CITY PLANNING COMMISSION

PROPOSAL: The applicant is requesting the necessary entitlements to develop 4± acres of commercial development and 506 apartment units for senior citizen housing.

APPLC. NO. P84-414

MEETING DATE April 12, 1984

TENTATIVE MAP
CREEKSIDE VILLAGE
CITY OF SACRAMENTO
SCALE 1" = 40'
DECEMBER, 1983

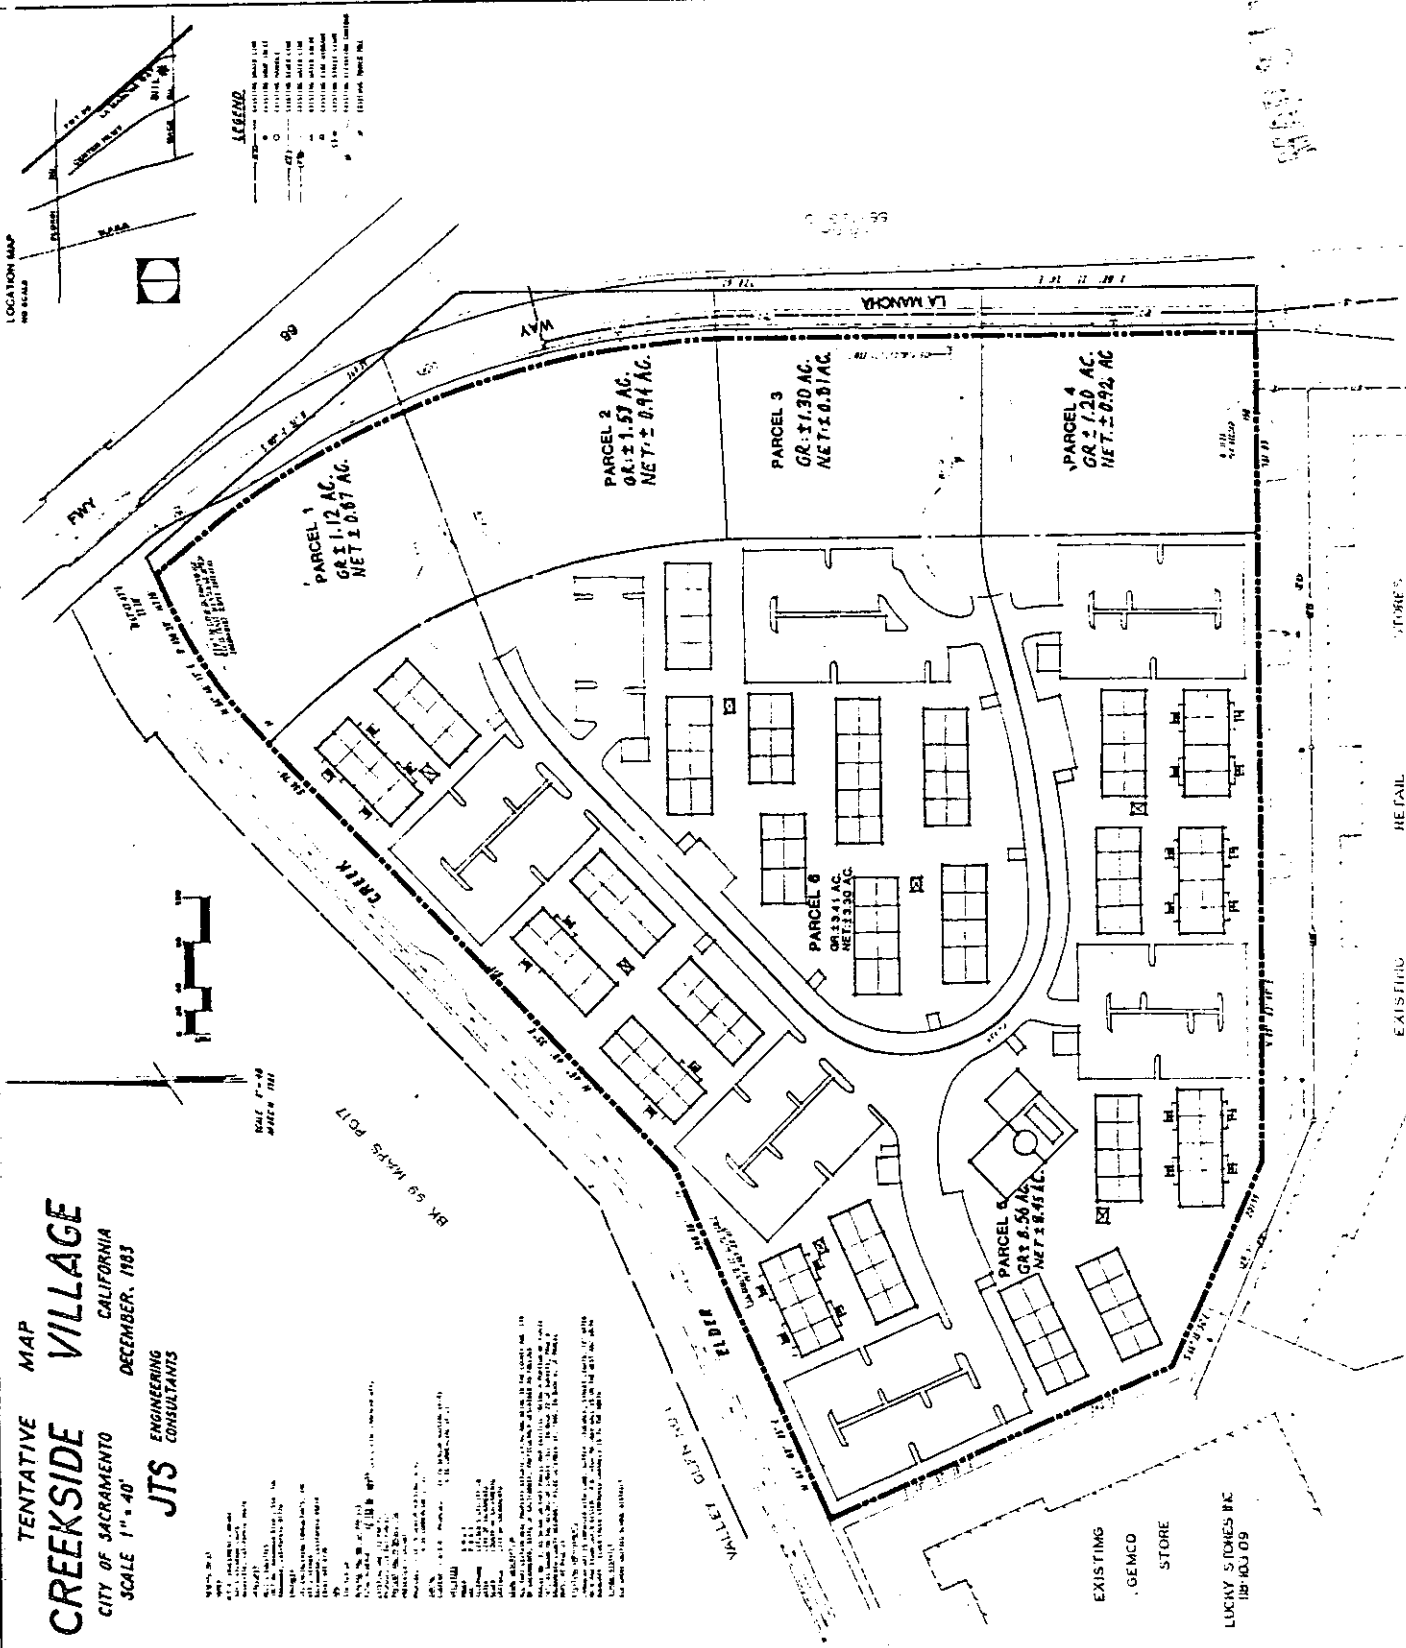
7. Provide easement for and construct access ramp to Elder Creek at La Mancha to the satisfaction of the City Engineer;
8. Dedicate right-of-access for lots 1 and 2 off of La Mancha Way to the City;

9. Relocate lot lines for Parcel 6 so that driveways are not bisected by these lines;
10. Prepare a right-of-way study for the review and approval of the City Traffic Engineer. Should a cul-de-sac option be utilized, the right-of-way study shall reflect this change;

- g. Provide easement for and construct access ramp to Elder Creek at La Mancha to the satisfaction of the City Engineer;
- h. Dedicate right-of-access for lots 1 and 2 off of La Mancha Way to the City;

- i. Relocate lot lines for Parcel 6 so that driveways are not bisected by these lines;
- j. Prepare a right-of-way study for the review and approval of the City Traffic Engineer. Should a cul-de-sac option be utilized, the right-of-way study shall reflect this change;

CONCEPTUAL SITE PLAN
CREEKSIDE VILLAGE
A PLANNED DEVELOPMENT BY MEDICI EQUITIES

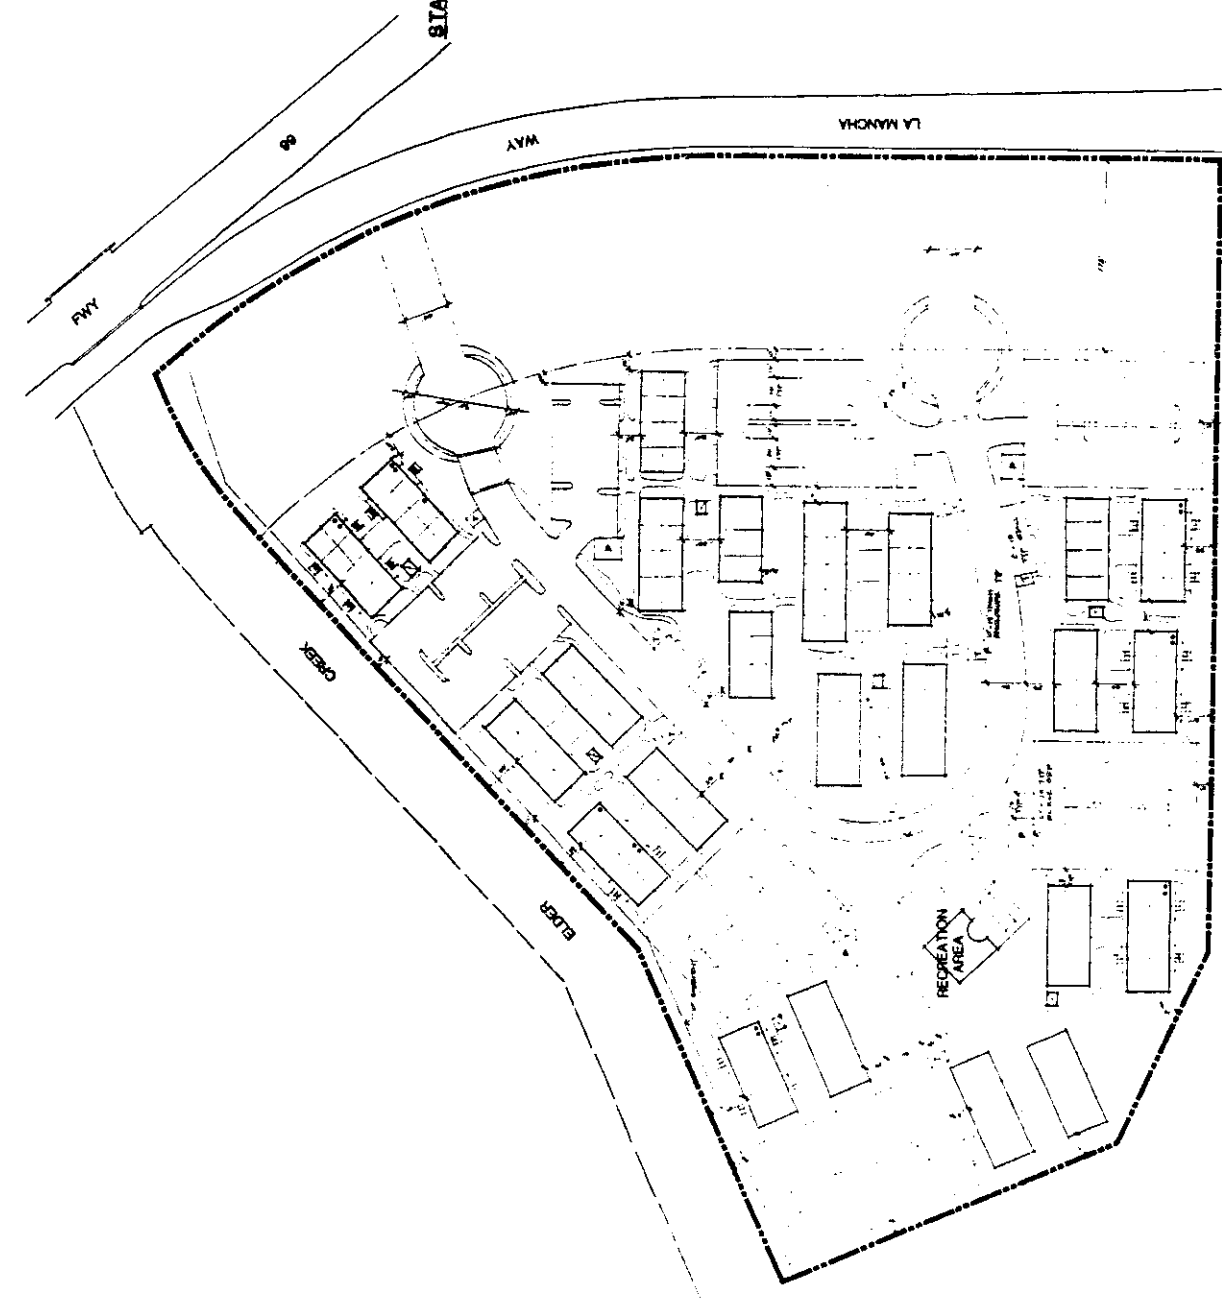
Recent developments within the Mack Road corridor achieve an average density of only 26 units per acre. Staff finds that the proposed density is not compatible with the surrounding land uses and, in general, inappropriate for a suburban area.

Staff does find some merit in an increase in density, but not to the requested R-4 zoning. Instead, staff recommends that the zoning be approved to a maximum of 36 units per acre, which corresponds to the R-3A zone. This density would allow for a development more in scale with the surrounding area.

- a. The site and elevation plans of the residential portion of the site shall be revised to reflect a maximum density of 36 units per acre. The majority of the apartment structures shall consist of one and two story structures;
- b. The applicant shall submit detailed landscape and irrigation plans for staff review and approval prior to issuance of building permits. These plans shall incorporate those design elements indicated in the PUD guidelines.

**CONCEPTUAL
 LANDSCAPE PLAN
 CREEKSIDE VILLAGE**
 A PLANNED DEVELOPMENT BY MEDICI EQUITIES

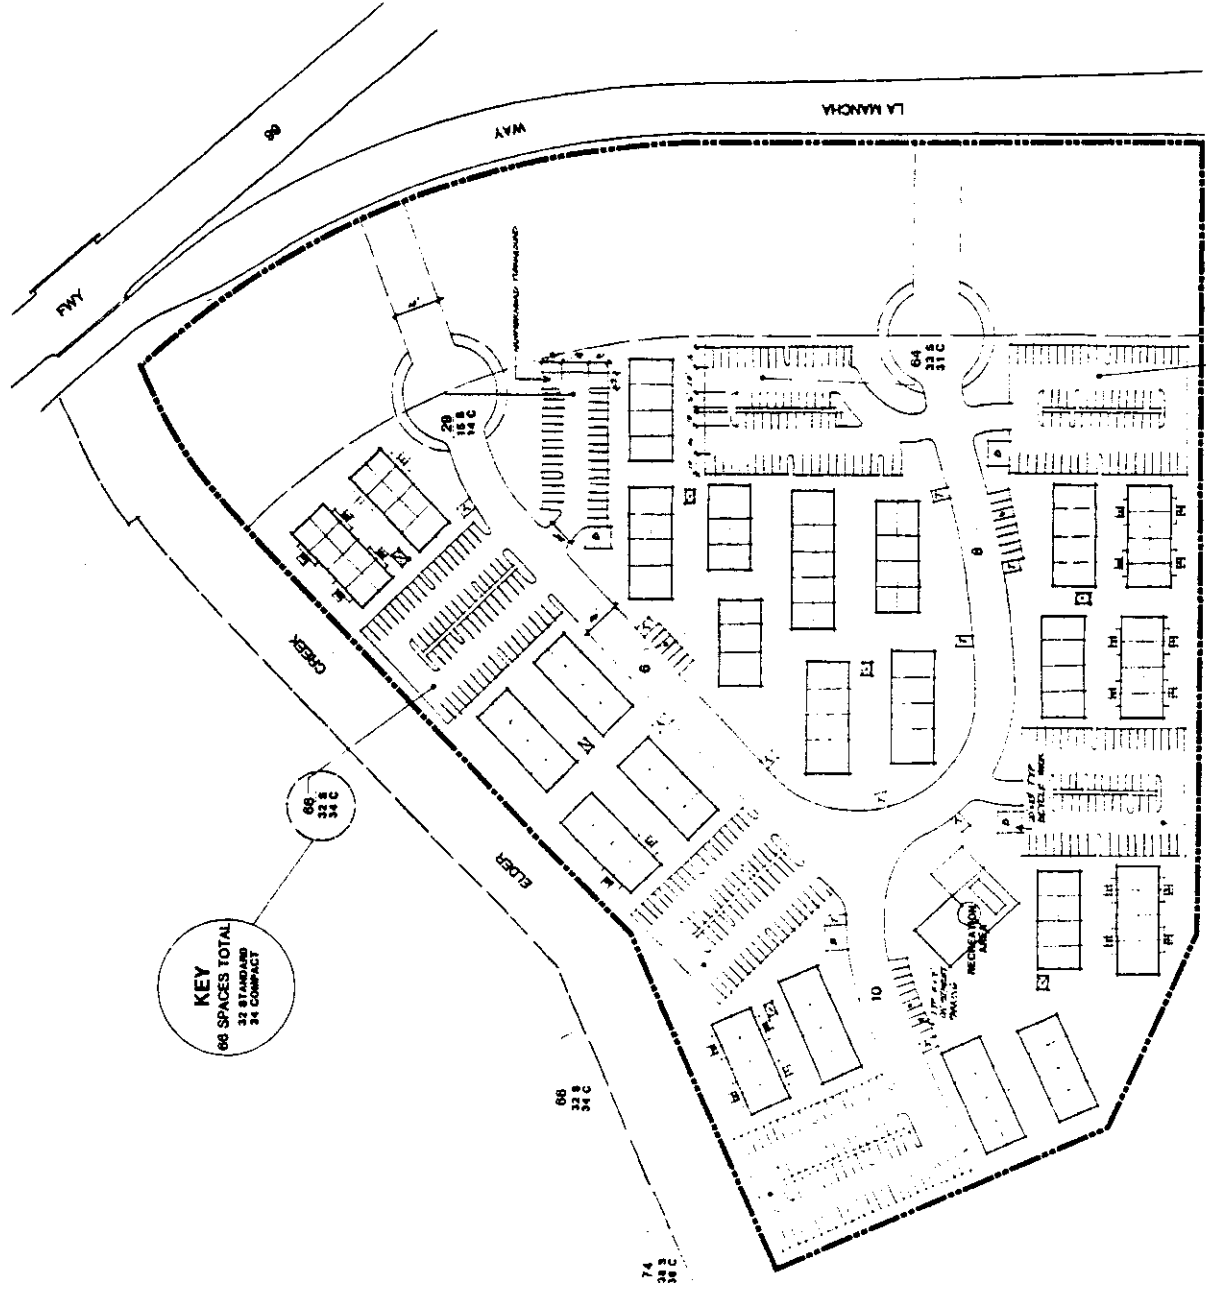
5. Parking Variance: Among the requested entitlements is a variance to reduce the required parking spaces for the residential portion of the site from 506 to 457 spaces. This represents a reduction in the parking ratio from one space per unit to .9 spaces per unit. Staff is not opposed to such a reduction because similar reductions have been granted for other senior housing projects. In addition, staff notes should the project revert to non-senior housing units the PUD guidelines require 1.5 spaces per unit.
6. Parkland Dedication: The Planning and Community Service Departments have determined that 4.45 acres of land are required for parkland dedication purposes and that fees are to be required in lieu of the required dedication. Based upon a preliminary review of the on-site recreational facilities, it appears that this acreage may be reduced by 40%.

The reduction in parking spaces shall be based upon the utilization of the residential portion of the site for senior housing only.

ARCHITECTURE + COMMERCIAL
CREEKSIDE VILLAGE
 A PLANNED DEVELOPMENT BY MEDICI EQUITIES

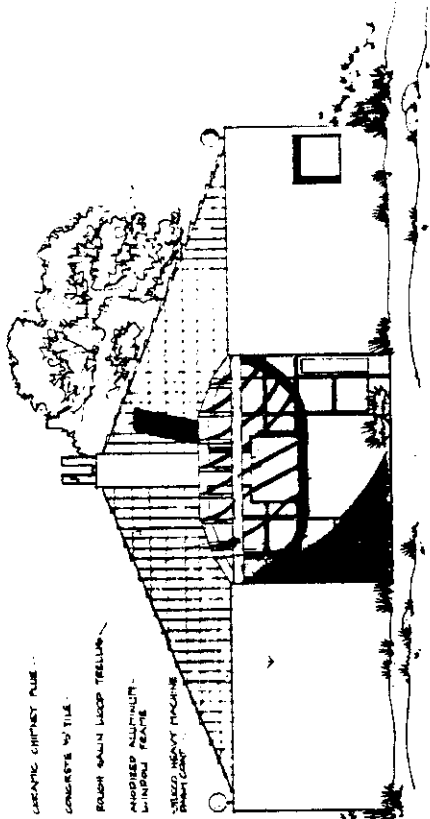
7. Commercial Building Plans: The applicant has submitted typical front elevation plans for the commercial portion of the site. In general, staff finds these plans acceptable. However, only the front elevations have been submitted. Staff recommends that the special permit for this portion of the site not be issued until such time as more definitive plans be submitted under a subsequent special permit.
